Technical Service Bulletin (TSB)
Telematics Box Module (TBM) Over The Air Software Update From 5.39.1 To 5.65

REFERENCE:	TSB: 08-219-25 GROUP: 08 - Electrical	Date:	July 18, 2025	REVISION:	—
VEHICLES AFFECTED:	<p>2022 - 2023 (DT) RAM 1500 Pickup 2022 - 2023 (DJ) RAM 2500 Pickup 2022 - 2023 (D2) RAM 3500 Pickup 2022 - 2023 (DD) RAM 3500 Cab Chassis 2022 - 2023 (DF) RAM 3500 10K LB Chassis This bulletin applies to vehicles built on and after May 12, 2023 (MDH 0512XX) and on and before August 31, 2023 (MDH 0831XX) equipped with a Global Telematics Box Module (Sales Code RDG).</p>			<p>MARKET APPLICABILITY:</p> <p><input checked="" type="checkbox"/> NA <input type="checkbox"/> MEA <input type="checkbox"/> SA <input type="checkbox"/> IAP <input type="checkbox"/> EE <input type="checkbox"/> CH</p> <p>NOTE: This bulletin applies to the North America market.</p>	
CUSTOMER SYMPTOM:	<p>Customers may experience the following:</p> <ul style="list-style-type: none"> 'SOS unavailable' popup message. 				
CAUSE:	TBM software

Fig. 1

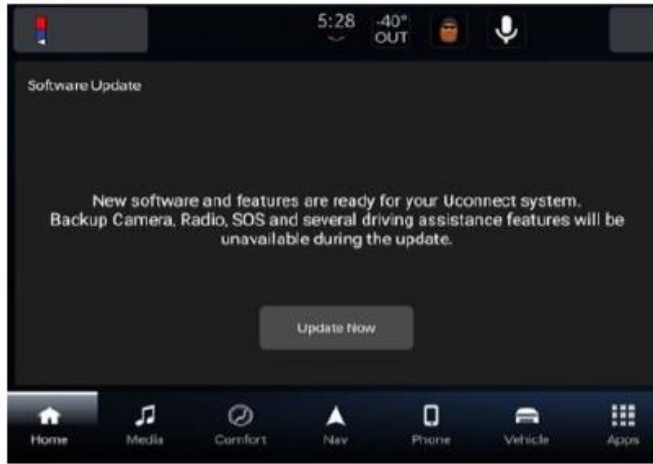
Vehicles sold in the U.S. and Canada can now receive software updates “over-the-air”. Updates to software will occur in a phased roll-out. The software is updated through a builtin cellular modem in the vehicle. Customers will see a notification on their radio screen when new software is available for their TBM [Fig. 1](#).

1. The vehicle needs to be in 'Park'. The ignition needs to be in the off position.
2. If the customer selects "Update Now" [Fig. 1](#) they can shut off the vehicle and leave. The update will be completed automatically.

Fig. 2

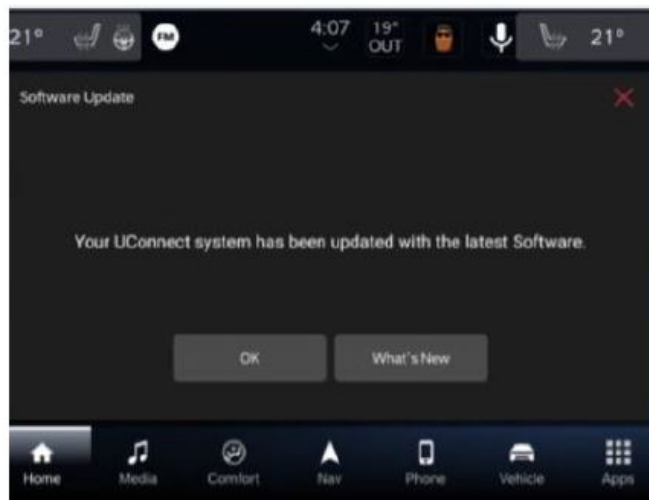
3. Upon completion of update, the radio will display a confirmation message [Fig. 2](#).
